CHESTER FOREST ESTATES CHESTER, CONNECTICUT

Environmental Review Team Report

**Prepared by the
Eastern Connecticut Environmental Review Team
of the
Eastern Connecticut
Resource Conservation and Development Area, Inc.**

**for the
Chester Inland Wetlands Commission
and
Chester Planning and Zoning Commission**

Figure 4
Site Plan
Not to Scale

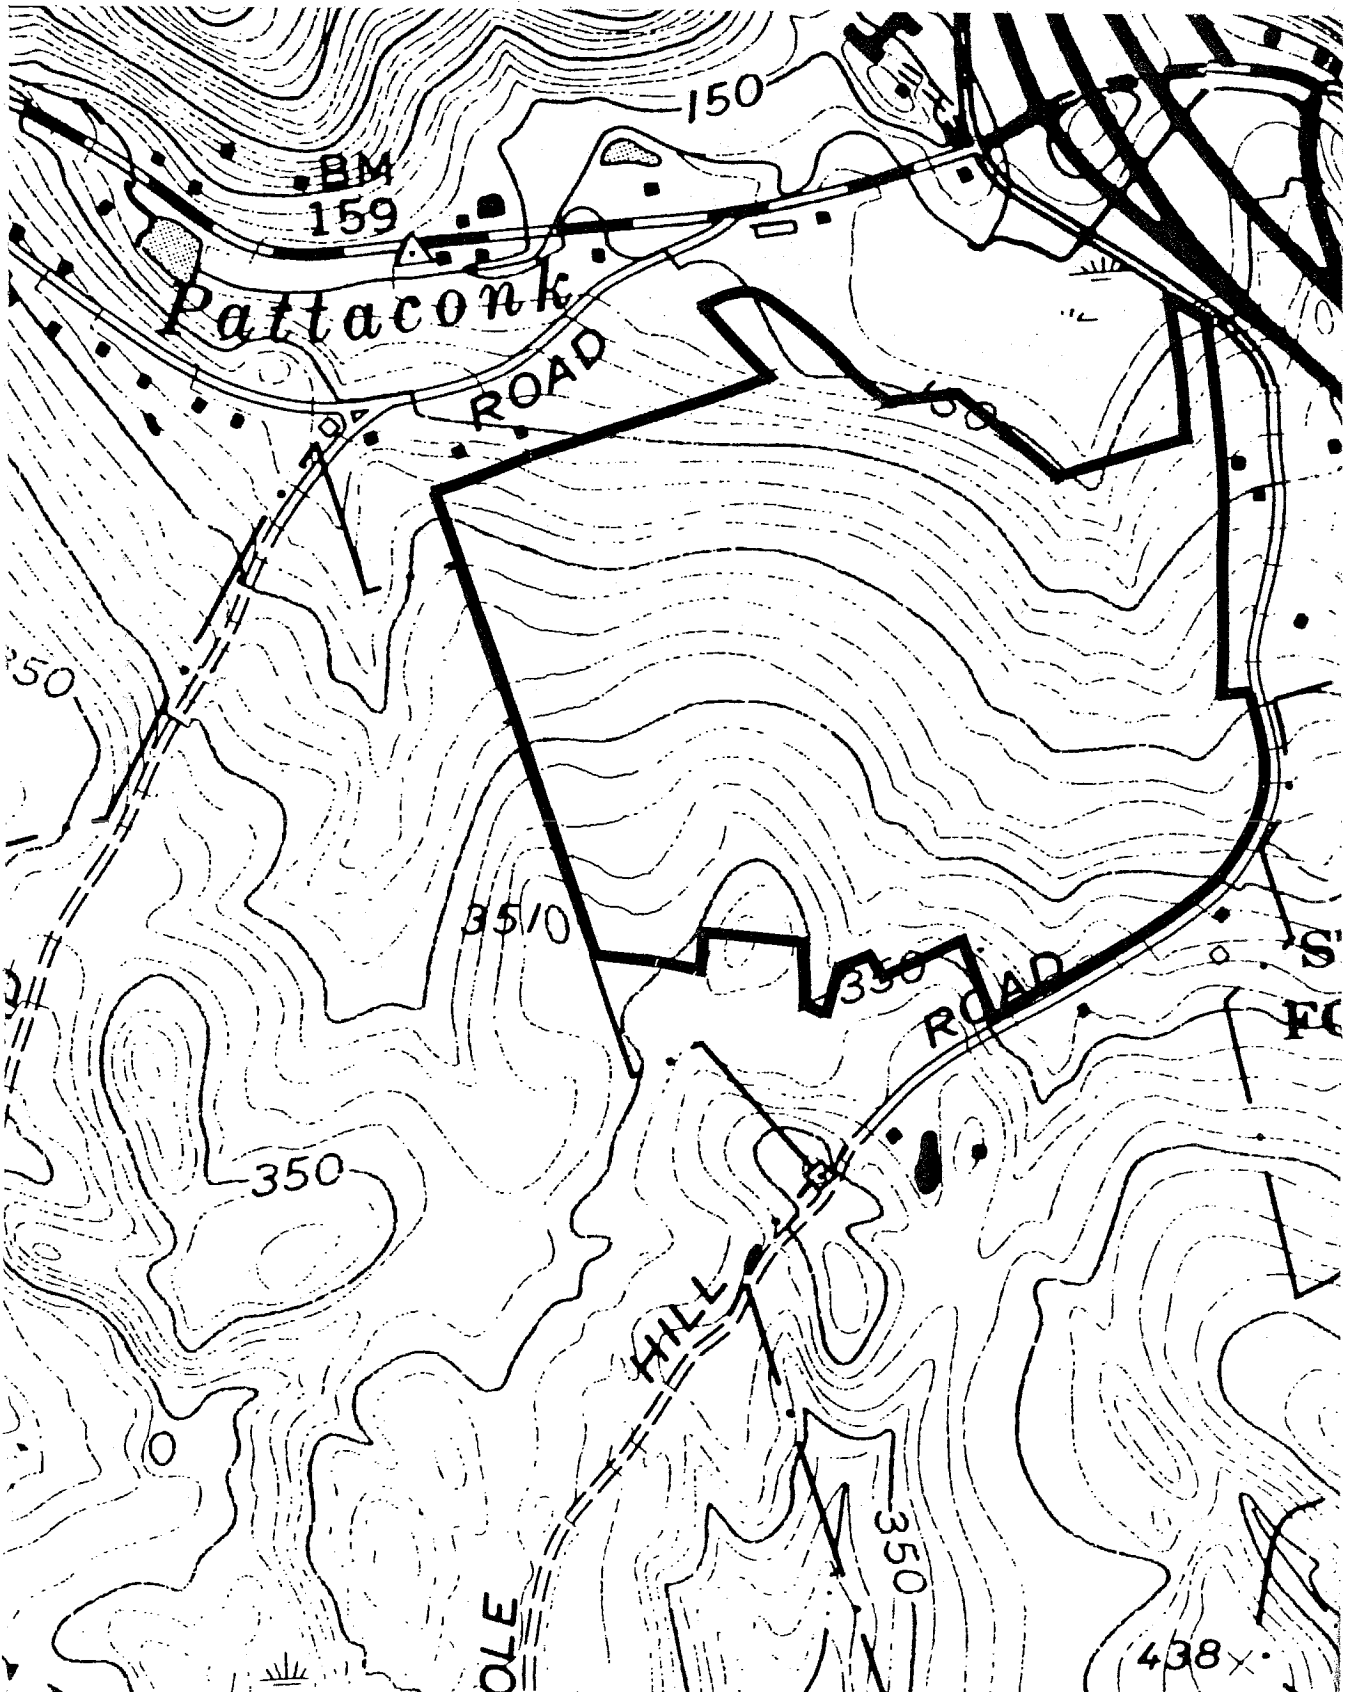
1. Alternatives to the subdivision design that limit proposed driveways and structures within the regulated 100-foot wetland review area (especially on slopes that grade towards wetlands) should be evaluated, i.e., proposed lots 4, 5, 17, 18, 19, 20, 21, 22.
2. A mechanism to impose and enforce proposed clearing limits shown on the site development plans should be evaluated. Undisturbed wooded uplands support wetland hydrology and provide soil erosion and sedimentation protection. Limiting the amount of clearing for the subdivision road and individual lot development will be critical to minimizing impacts to site wetlands. The amount of clearing shown for buildings, driveways, and lawn

3. An alternative subdivision road design to minimize the total amount of wetland and 100-foot regulated wetland review area disturbed should be evaluated. The potential to move the road crossings to narrower wetland areas with shallower slopes should be evaluated, i.e., between lots 16 and 18 at wetland flags 42-46 and 102-105.

4. Stormwater should be detained in upland areas, not in wetlands as proposed. Although the area and duration of the flooding behind the detention structure may be limited, the size and nature of the structure may permanently impact the wetland. The size and permanent impact of the detention berm crossing should be compared to the size (height and width) of a standard driveway crossing. In addition, the necessity of providing detention for the 100-year storm should be evaluated with respect to the size and impact of the proposed detention structure.

4. Construction entrance anti-tracking pads should be indicated at the driveway entrance to lots 1, 2, and 3 on Hoop Pole Hill Road.
5. There is a holding tank ("HT") specified at the subdivision entrance. If clearing, grading, or excavating is required in this area an appropriate sediment barrier measure should be specified on the site plans.

6. An appropriate sediment barrier measure must be shown for the rip rap splash pad at the outlet of the first wetland crossing (at lot 2) of the subdivision road and at the third crossing at the shared driveway to lots 20-22. The site plans show a geotextile silt fence transecting the splash pad at the first crossing.

9. A method to intercept or divert potential erosive flows or sediment from driveways that grade towards the subdivision road (lots 4-10) should be evaluated. Measures should be provided to control material from the driveway construction from getting onto the subdivision road (especially after it is completed and sedimentation protection is removed from the road drainage system).

10. Sedimentation barriers or filters (geotextile silt fence or hay bales) should be used on the downslope sides of driveways, parking areas, and houses to protect undisturbed areas and remaining vegetation from sedimentation. Measures should be provided to control sediment until the area is stabilized. (e.g., driveways to lots 7, 11, 12, 13, 14, 20, 21; parking pad of lot 17, north side of house on lot 1, northeast side of house on lot 20, north of house on lot 21).

11. Adequate E&S protection and access to the primary septic fields needs to be shown for lot 7 (overlap in fence needed) and lot 16 (a break in the fence needed). Overlapping lengths of silt fence can be placed on the contour with 20 feet vertical separation on the slope.
